Response to NRC ltr dtd 03/16/78...
Furnishing addl info re the FPL system
disturbance which occurred on May 16, 1977...
w/att...
1/4"PLANT NAME: TURKEY POINT UNITS 3 & 4
ST LUCIE UNIT 1
jcm 04/08/782 ENCL - REPRO ADD'L CUS
2 SETS DRWGS - TO FILES &
PDR

Re: Florida Power & Light Company (FPL)
Docket Nos. 50-250, 50-251, and 50-335
Request for Additional Information

Re: Florida Power & Light Company (FPL)
Docket Nos. 50-250, 50-251, and 50-335
Request for Additional Information

FIGURE 4A2-1

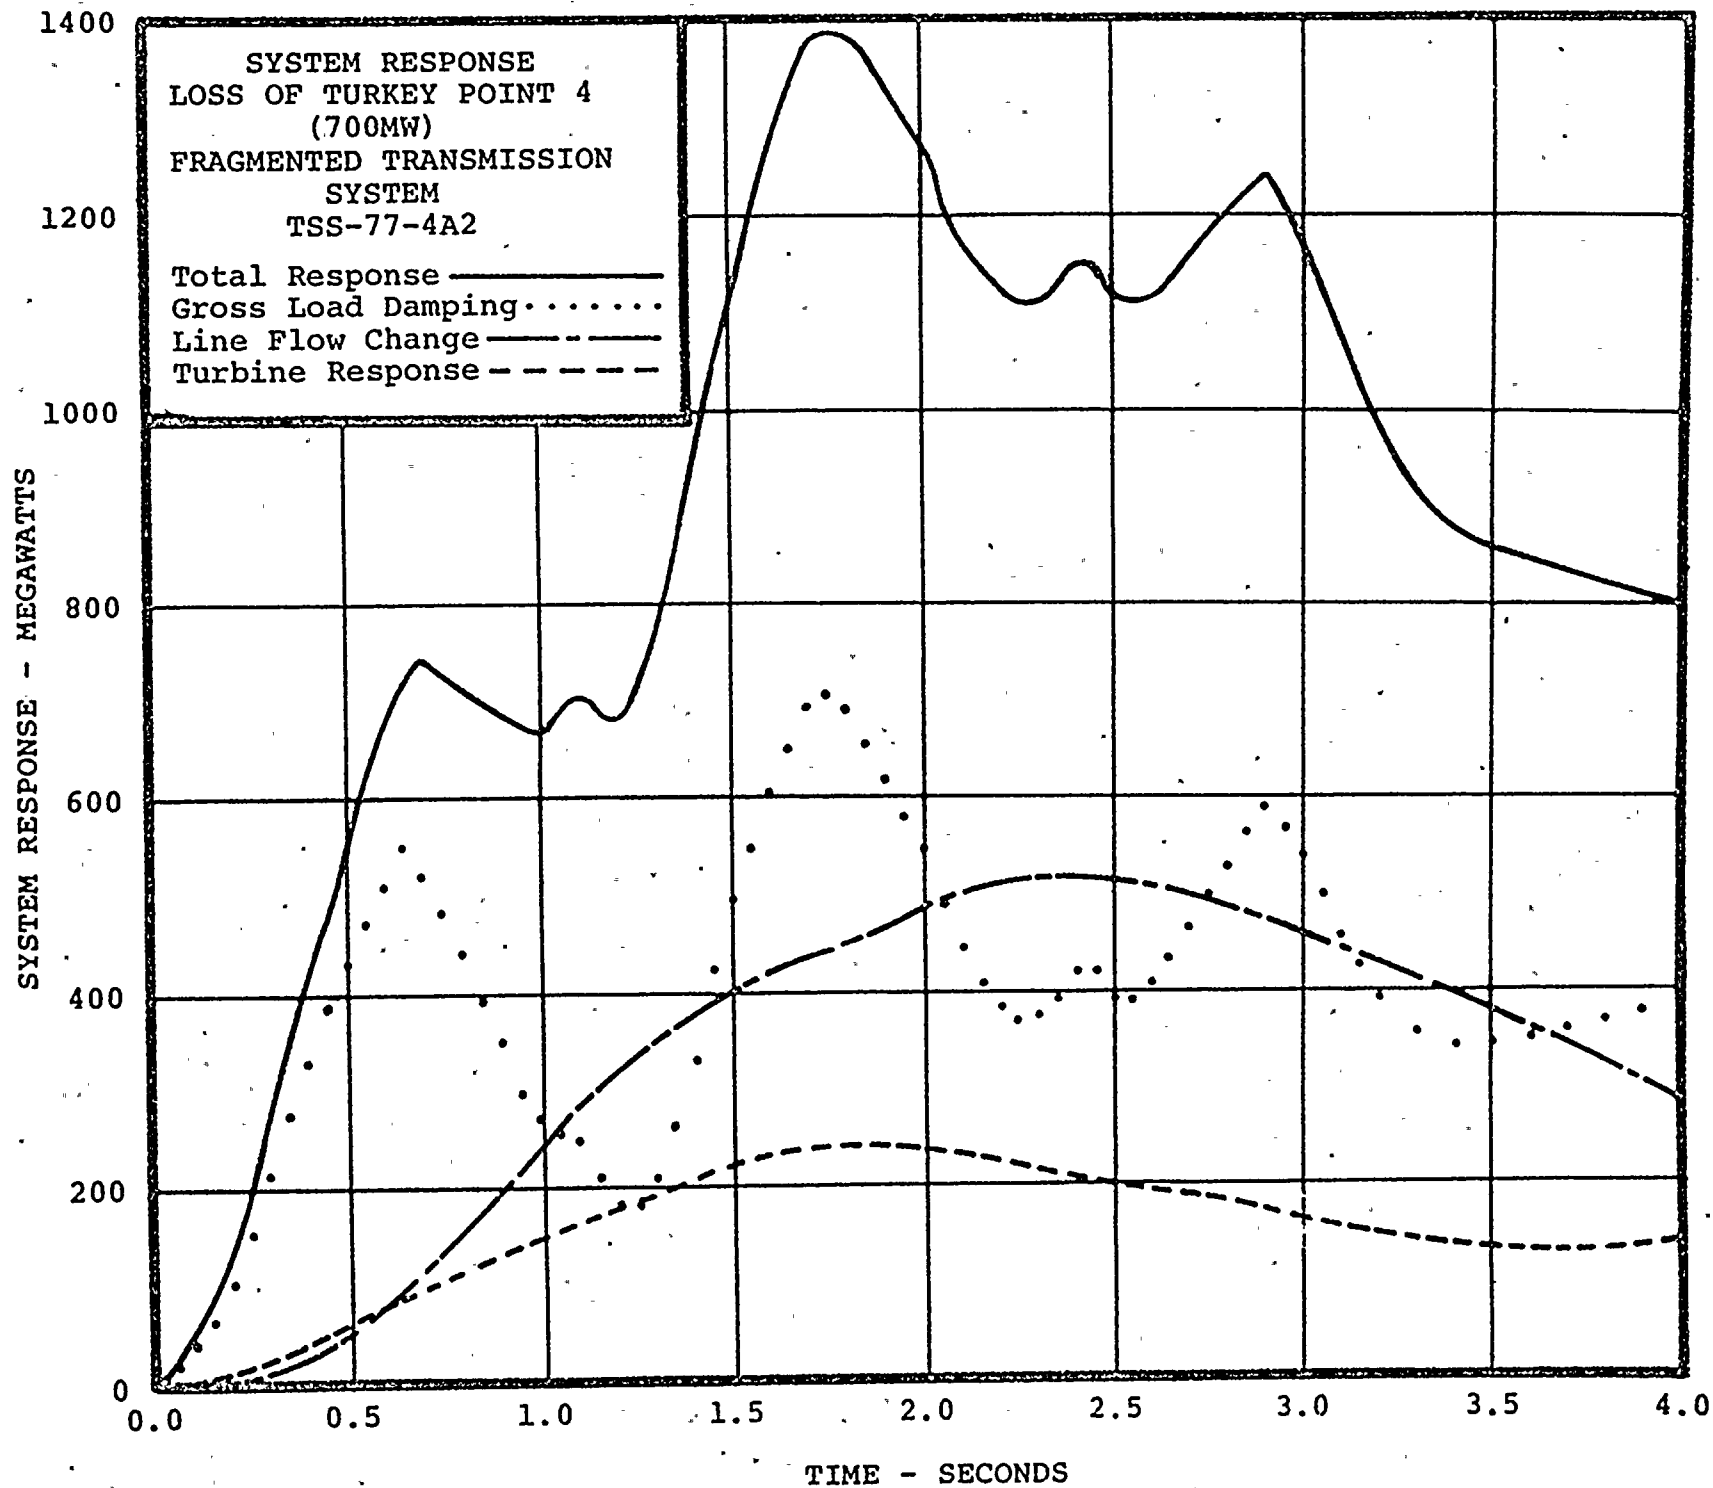
The response to request 3 appears to suggest that the calculation involving the loss of Turkey Point 4 in the FCG study is to be considered to bound the events which occurred around 10:08 on 5/16/77. If this suggestion is intended, please furnish a detailed description of this calculation showing relevant detail which causes it to be regarded as bounding.

System response recovered the 700 MW loss by $T = 0.7$ second. The largest initial contribution was from load damping, followed respectively by tie line flows and turbine response (see Figure 4A2-1). The load damping peak was 697 MW at $T = 1.7$ seconds; turbine response peaked 0.1 second later at 243 MW.

AREA LOADS

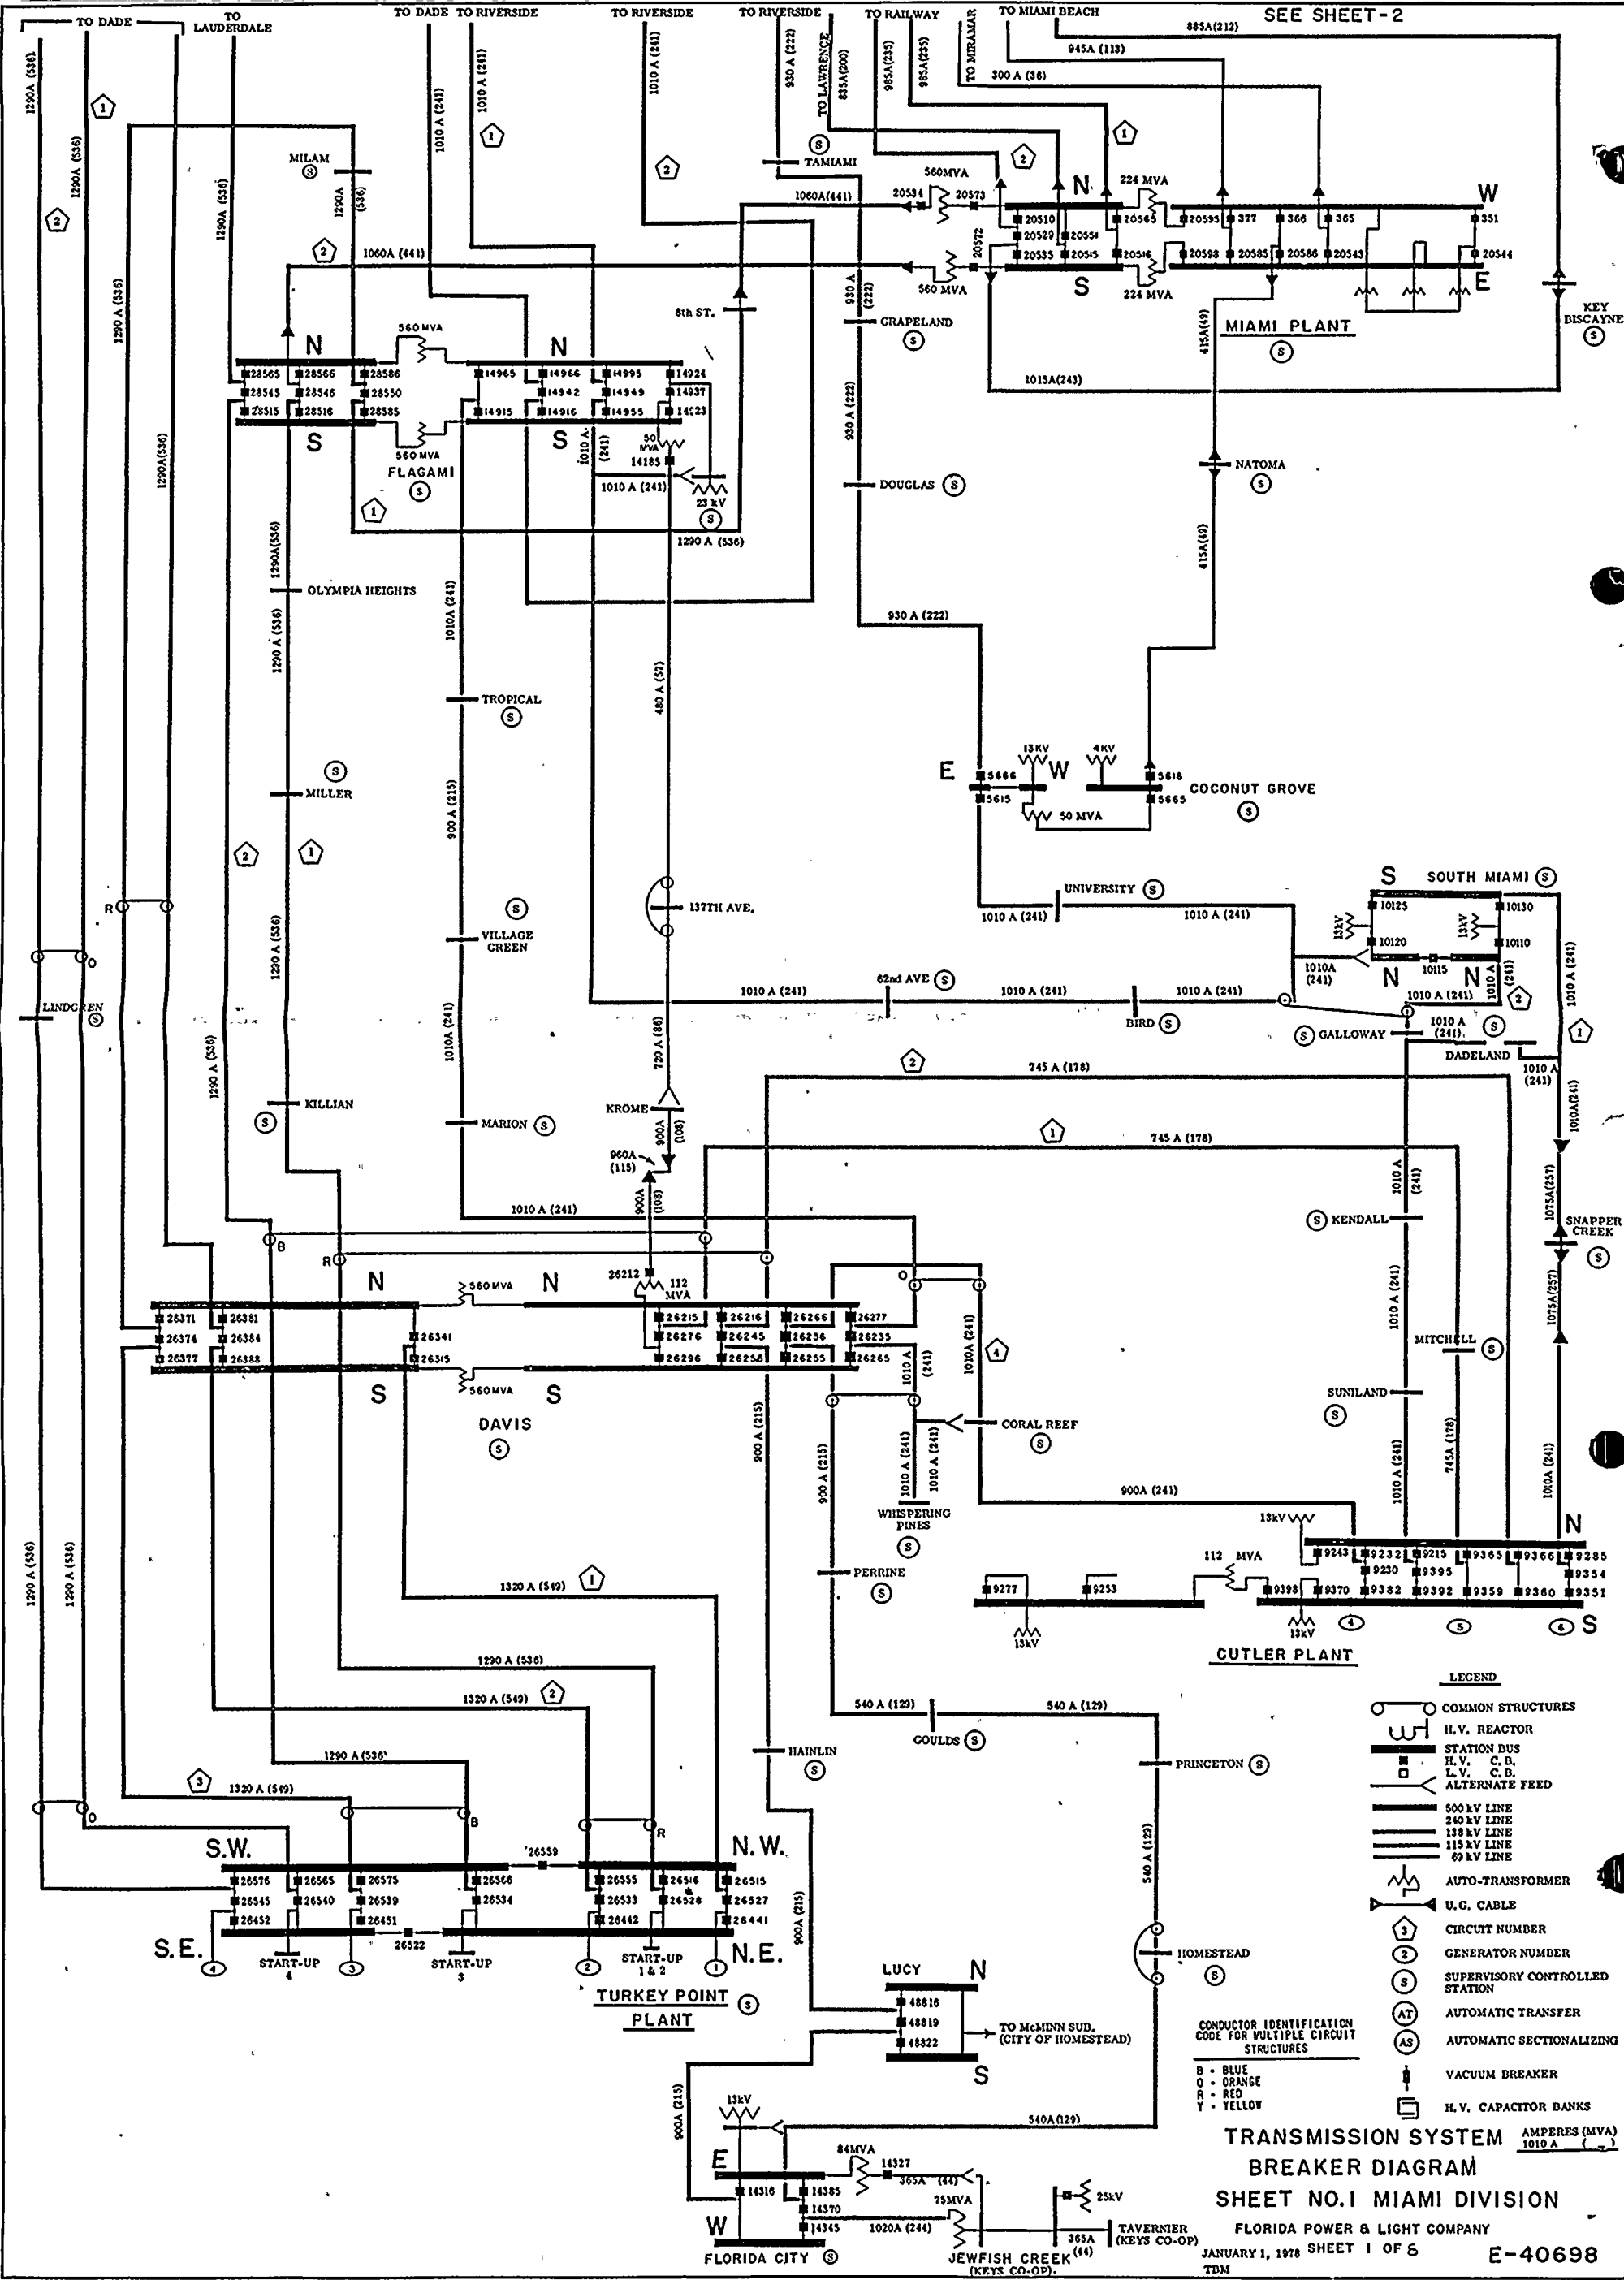
The power estimates given in response to request 1.6 are not supported by the data on which they were based. Please provide the 16-minute (10:08-10:24) record of each variable that was used in making this power calculation and a sample of how the calculation was made.

- a) Power available to the Western Division is the sum of the output of the plants in the Western Division minus the tie flows to Tampa Electric Company (flows into Florida Power & Light are negative numbers). These values are obtained from the various strip charts for the time period under consideration. (Charts were previously transmitted.) An additional chart "Area Loads" is attached to verify the 'before' load. (Appendix C)
- b) Load in the Western Division: Load prior to the disturbance is obtained from the strip chart showing the area loads. After the initial disturbance, the area load chart showed

a load in the Western Division which, if true, would have indicated a reduction in line flows from Ft. Myers to Ranch. The known deficit of generation in the south, the observation by plant personnel at Fort Myers and the alarm signal from the West Palm computer, all indicate that the power flows from Fort Myers to Ranch did indeed increase. There was no interruption of feeders in the Western Division but during this period the area substation load would increase; any other change in area load is due to a change in the transmission line losses in the Western Division. An estimate of the total load in the Western Division was made.

CHARACTERISTICS FOR PHASE RELAYS
 LINE FT MYERS - RANCH 240 KV
 TERMINAL FT MYERS
 BASED ON SETTINGS DATED 12-10-76
 DRAWN BY A.S.

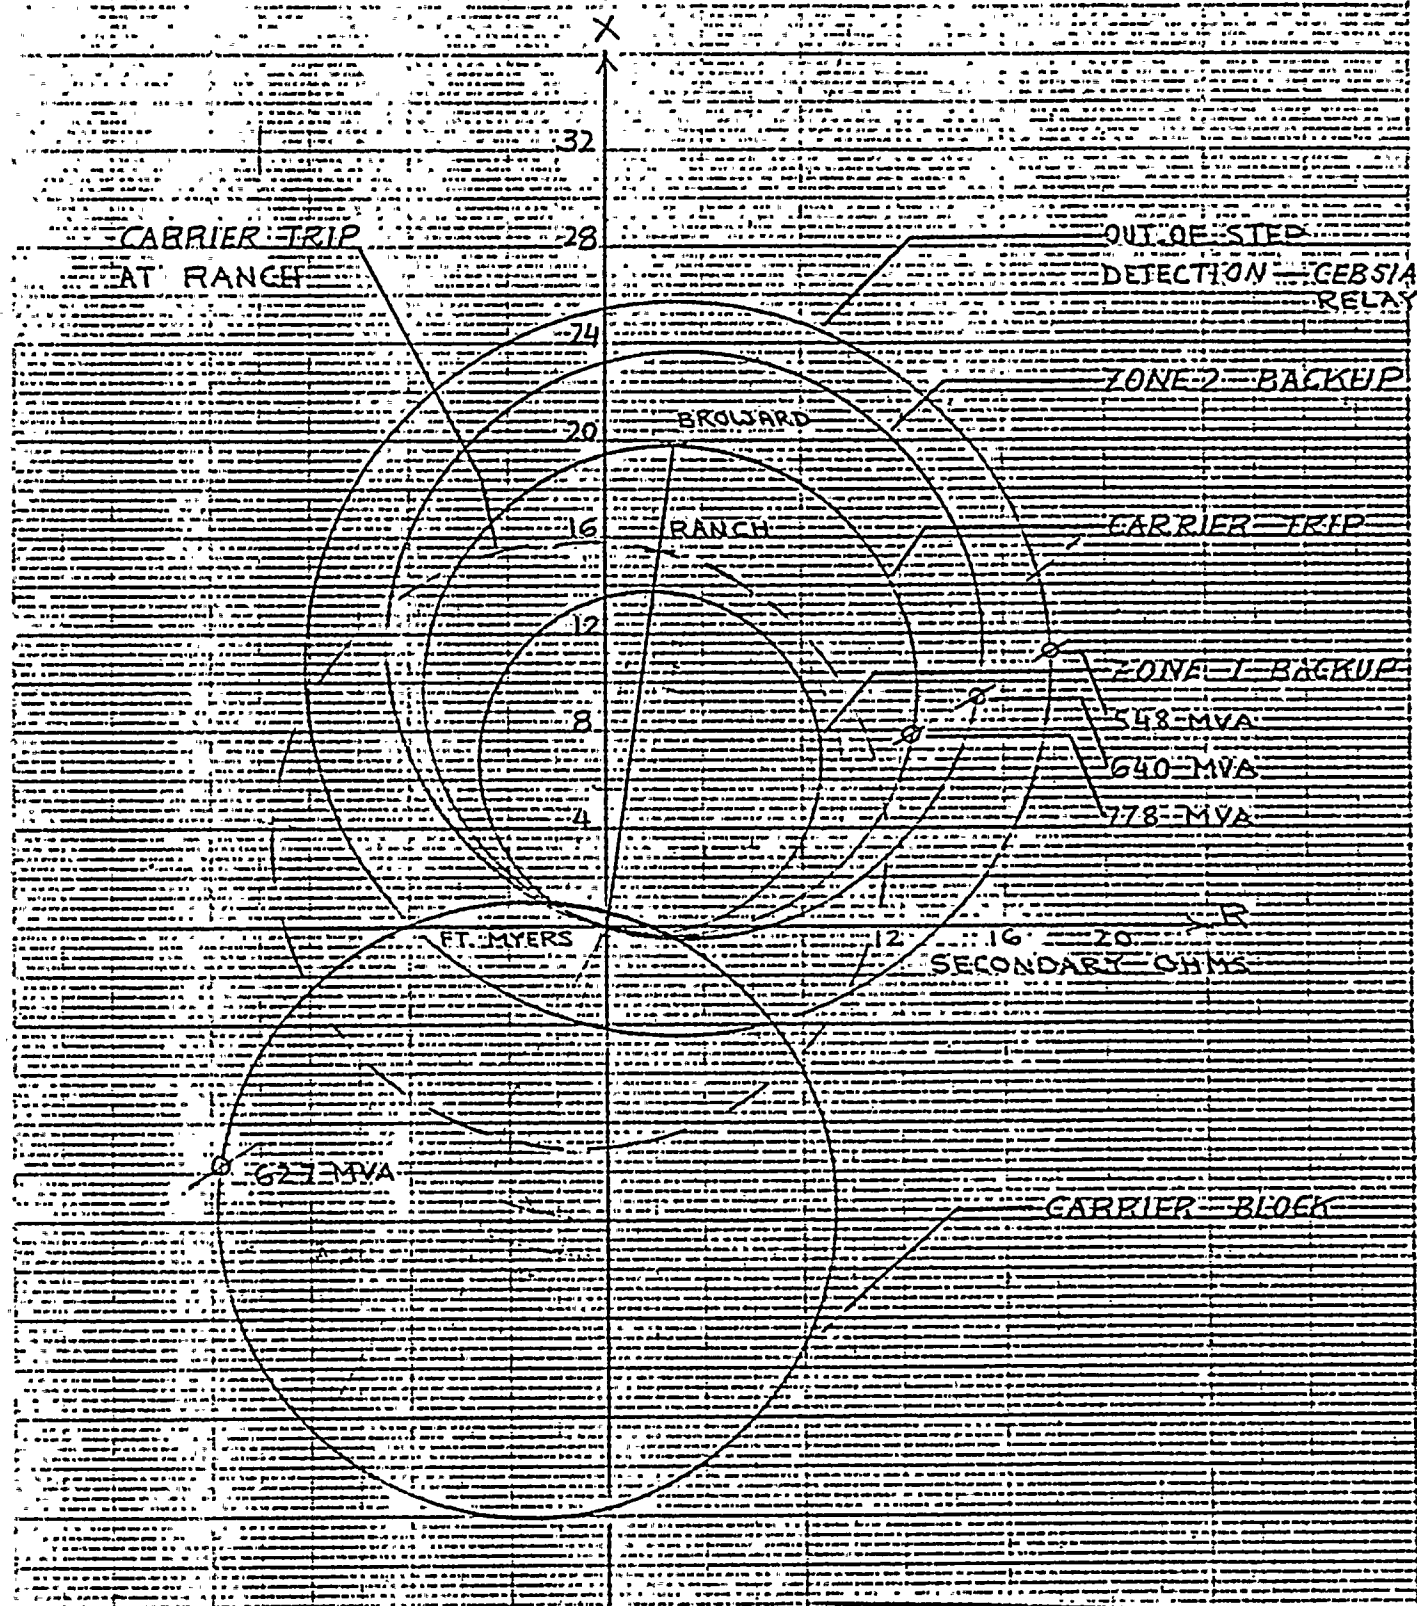
The response to request 2 "We have concluded that the Turkey Point trip could not by itself, have caused the line to relay" is not supported. Please furnish any supporting analyses with a full description.

- 9) The line loading of the Fort Myers-Ranch line was well under the tripping value.

Setting sheets are attached (Appendix D) with a plot of the relay characteristic in terms of R & X and a plot in terms of watts and vars.
